MAIN COMMENTS:

Condition 3

(POS planting Schedule)

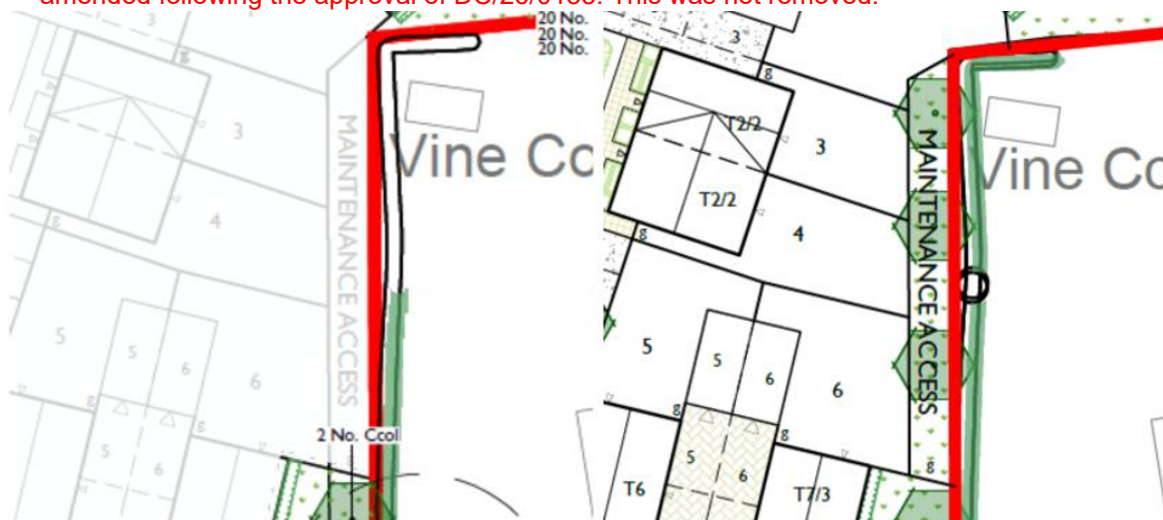
- a. No concerns raised with species proposed, however this is subject to change regarding the Central Focal Space as per point 1b. **This has now been amended following the approval of DC/26/0135.**
- b. A larger variety of tree sizes is requested for instant maturity and visual amenity in key areas, such as the access road on approach to the development. Please amend accordingly. **The tree sizes were approved as part of the original RM and they haven't**
